CALIFORNIA COASTAL COMMISSION

Addendum

Subject: Addendum to **Item 25a**, Coastal Commission Port Master Plan
Amendment **#6-PSD-MAJ-43-12 (San Diego Marriott)**, for the
Commission Meeting of November 15, 2012

Revised Marriott Hall Site Plan

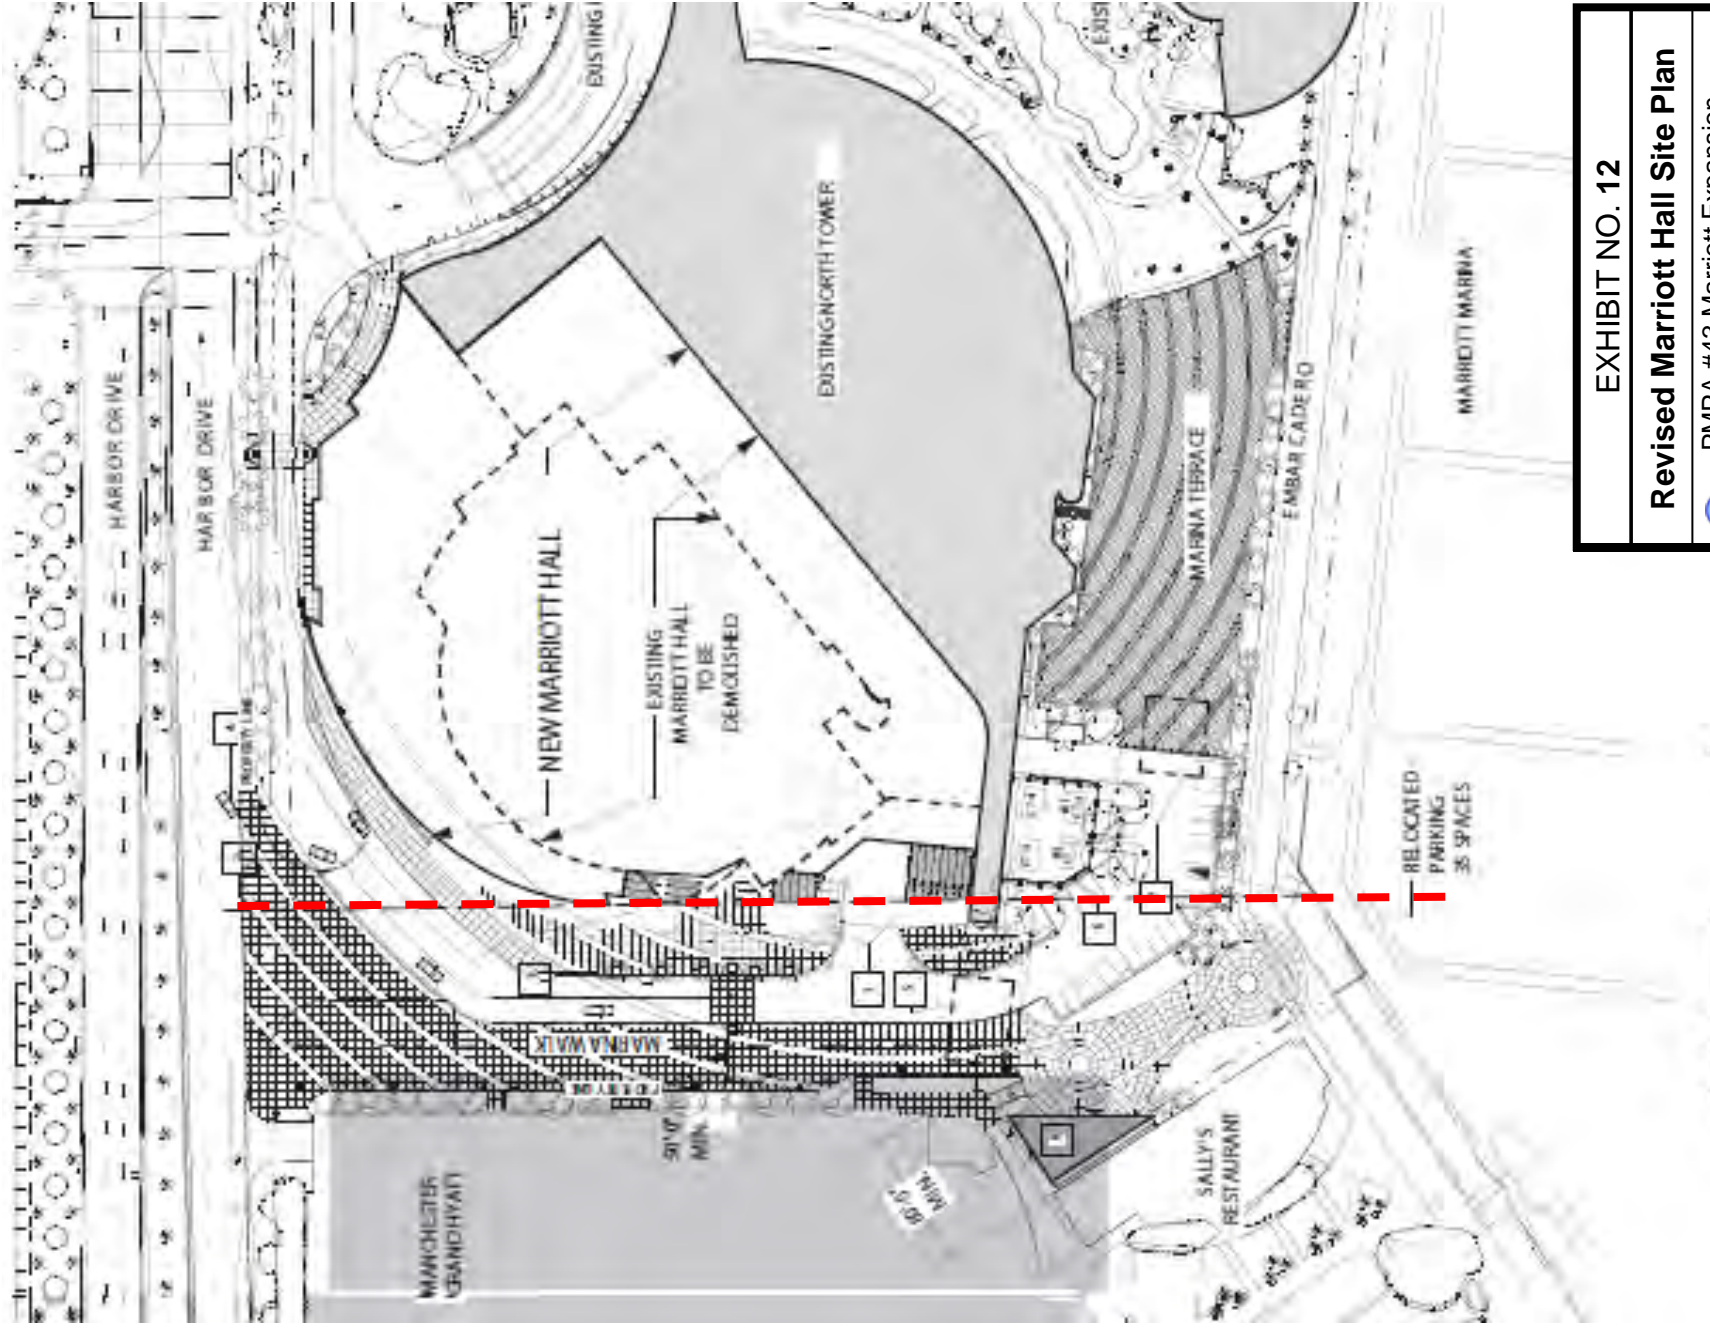
These are clearly significant improvements; however, the timing of the most recent revisions does not allowed staff sufficient time to review the changes to the site plan and the necessary corresponding changes to the text and make a revised recommendation in writing. The most recent project changes and any potential revisions to the staff recommendation will be addressed verbally at the public hearing for the project. The Port's revised submittal is attached as an addendum to the staff report. A portion of the revised plan is attached to this addendum as Exhibit #22

Marina Walk Cross-Section at 50' wide

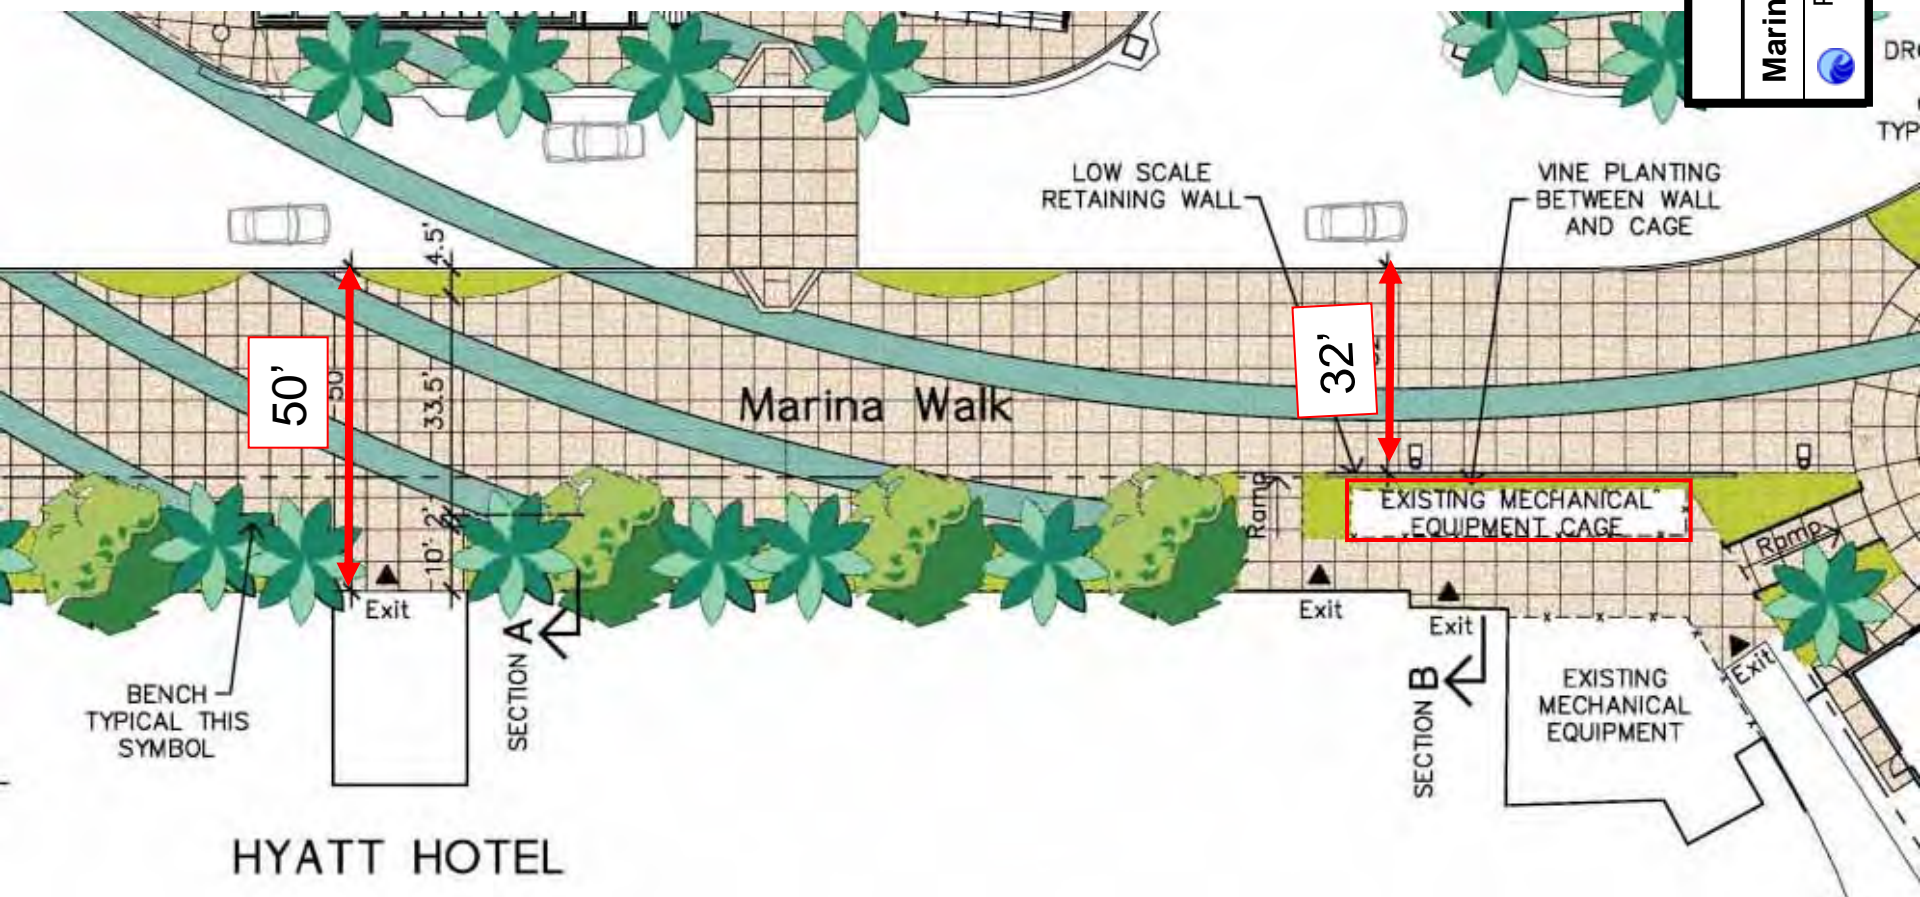
They recommend on view corridor: maintain 121 width between Marriott Hall and Hyatt and remove view obstructions. Marina Walk to have a minimum width of 50 feet. [they will have to reduce the size of ballrooms. They don't care the size, so long as it maintains the 121 feet width.

Area of Sally's Remodel

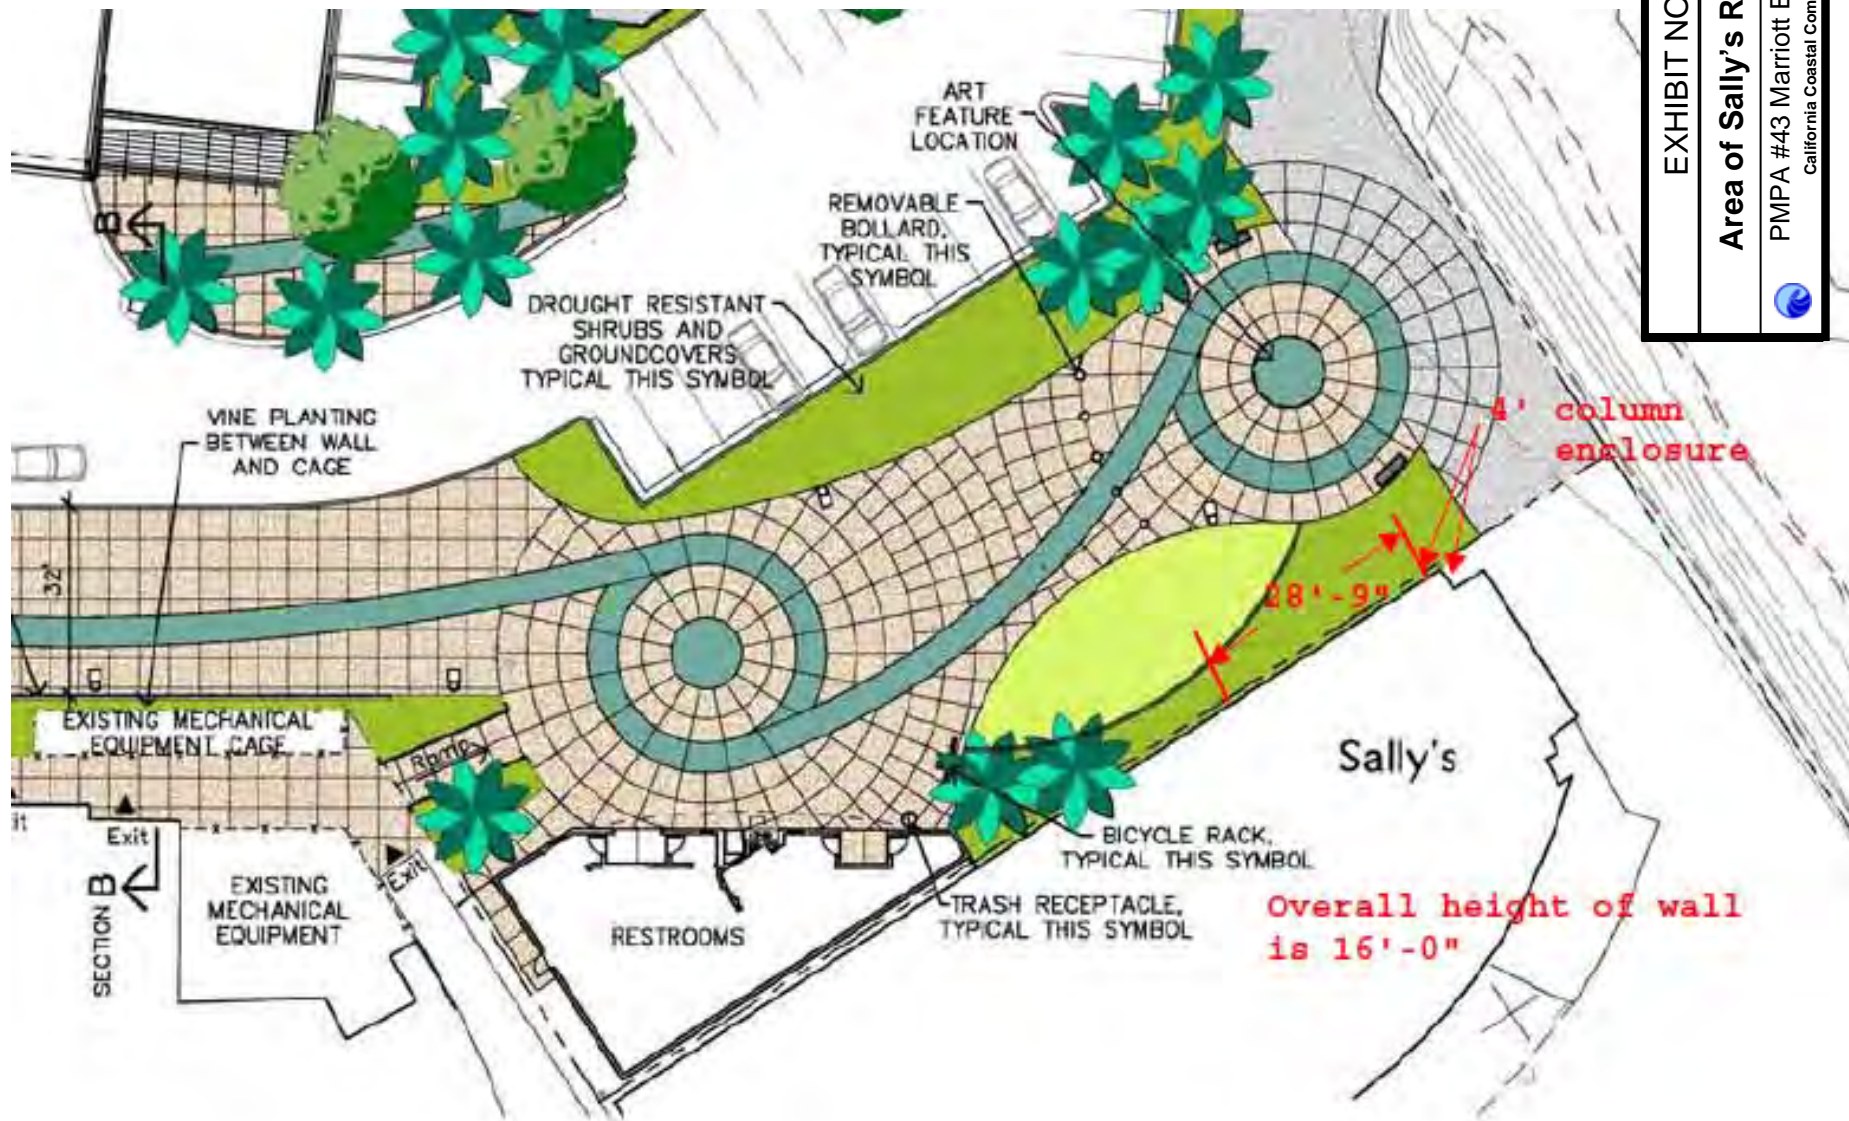
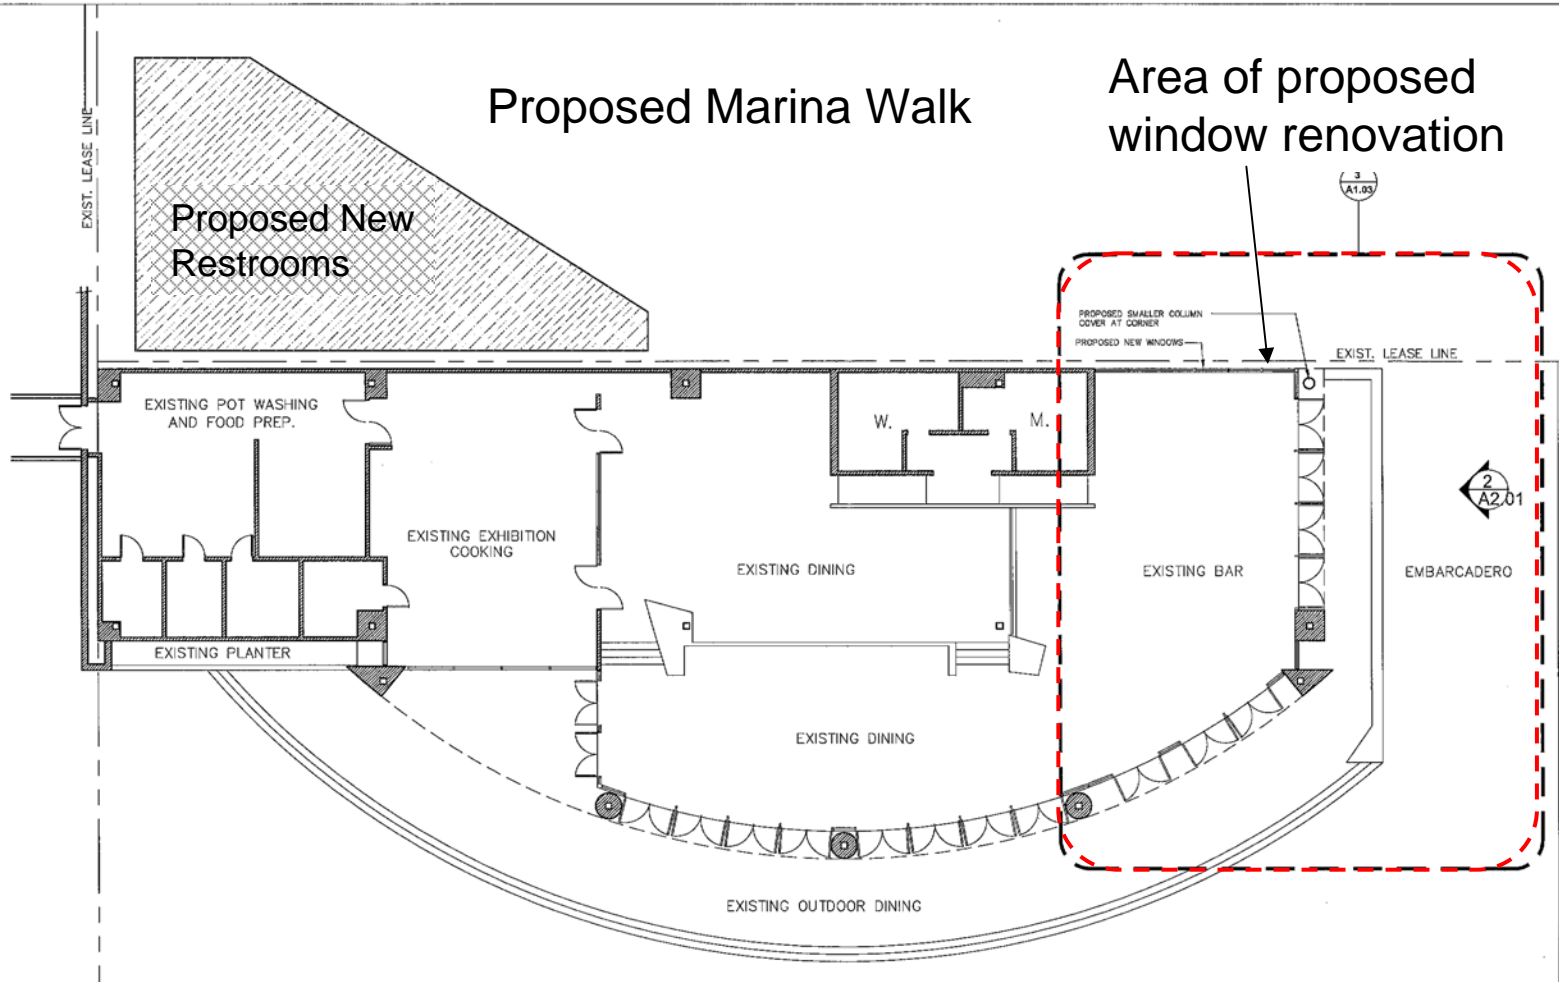
This was another Hyatt condition: quote from Hyatt CDP- remove or remodel walls of Sally's restaurant to give the public **a clear view**. Their proposal does not do it, they propose to put in windows where there is a solid wall. This was not part of the approval, it was an example, and Wan does not remember it being attached to the staff report. removing the walls of the restaurant will provide a huge difference in the view. This is one area where they don't agree with staff.

What about remodel of Sally's? CDP requires either renovate or remove. They have chosen to do the option of glass. Even though Host owns both hotels so they have no control over what the Hyatt operator does. The glass will enhance the views even further.

Jones: the concept plan referenced in the Hyatt CDP showed removal of glass. The Commission did not act on the CDP, that was a Port CDP that was not appealed to the Commission. They actually got a copy from CCC files.
